06 May 2022  
Ref: 21164

**Proposed Residential Development  
22 Redan Street, Mosman**

I have assessed the revised plans relevant to Council's Statement of Facts and Contentions.

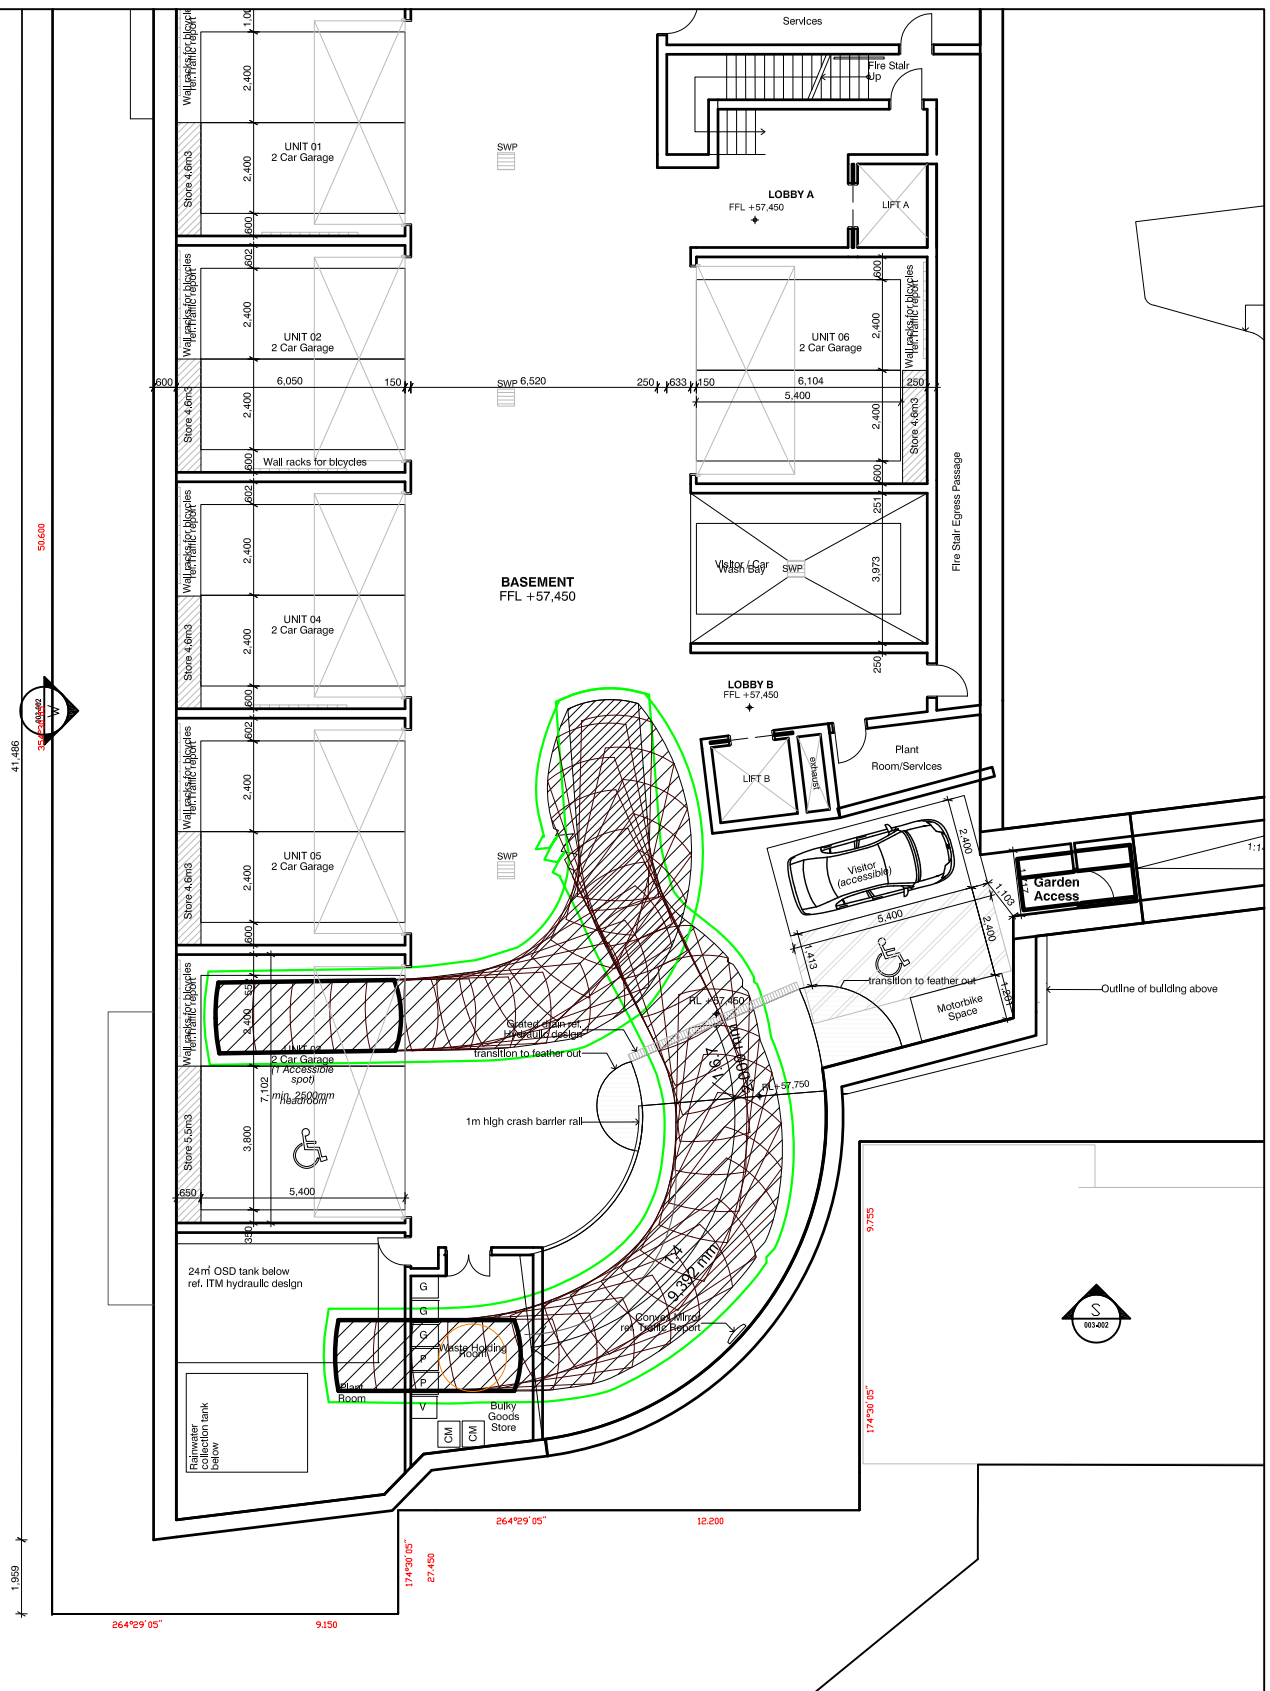
- (a) The turning paths for the Unit 4 & 5 parking spaces are satisfactory as shown on the attached diagrams
- (b) The dimensions are now shown on the parking spaces
- (c) A car wash bay is now provided in accordance with the DCP criteria
- (d) A motorcycle space is now shown in accordance with the DCP criteria
- (e) The sight distance in relation to Fig 3.2 of AS2890.1 is compliant due to the speed hump constrained speed in Redan Street at the site frontage.

The site distance in relation to Fig 3.3 is indicated on the plans.

**SP 9**

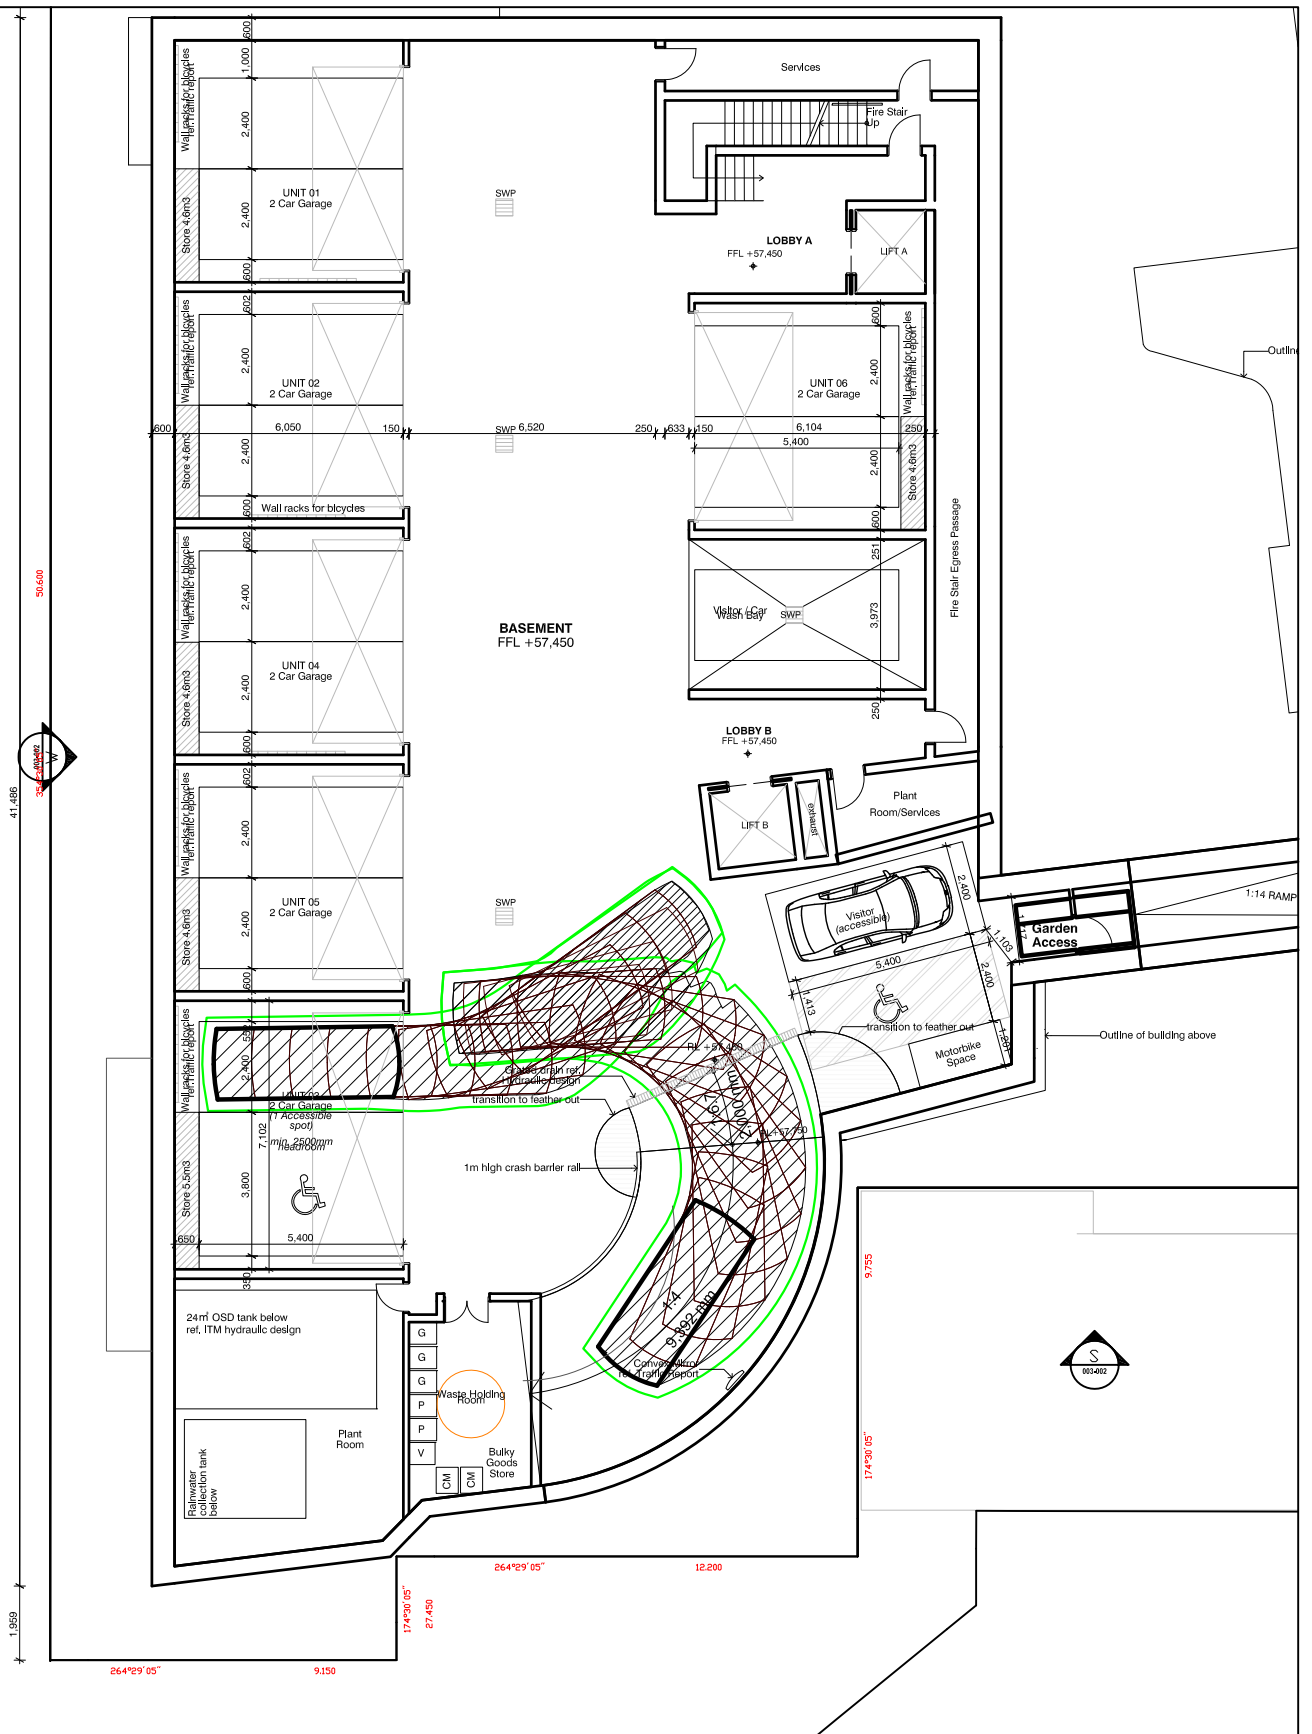
**SWEPT PATH ANALYSIS  
OF AN 85th PERCENTILE  
VEHICLE ENTERING THE SITE**
